# Service Bulletin: SB 99

**GAME:** NBA Fastbreak

**SUBJECT:** For a ball trap on the right ramp

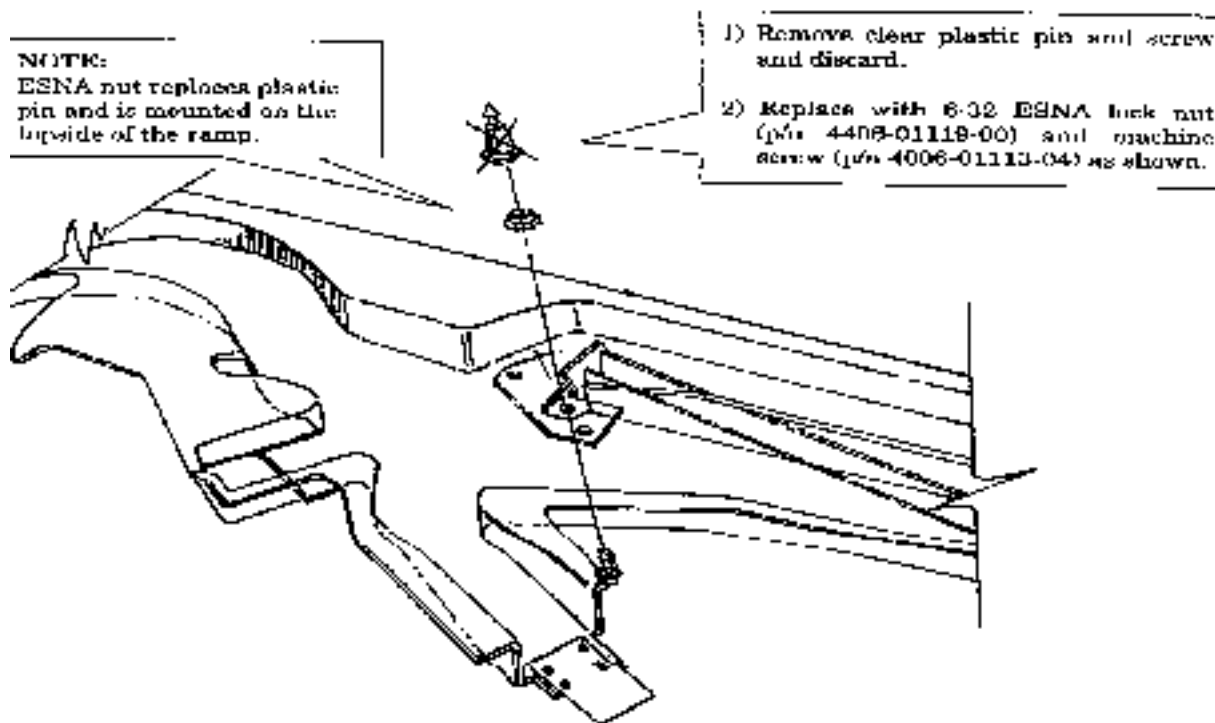
If your NBA Fastbreak traps a ball at the plunger lane entrance to the right ramp, implement the following change.

**Note:** ESNA nut replaces plastic pin and is mounted on the topside of the ramp.

- 1) Remove clear plastic pin and screw and discard.
  - 2) Replace with 6-32 ESNA lock nut (p/n 4408-01118-00) and machine screw (p/n 4006-01113-04) as shown.
-
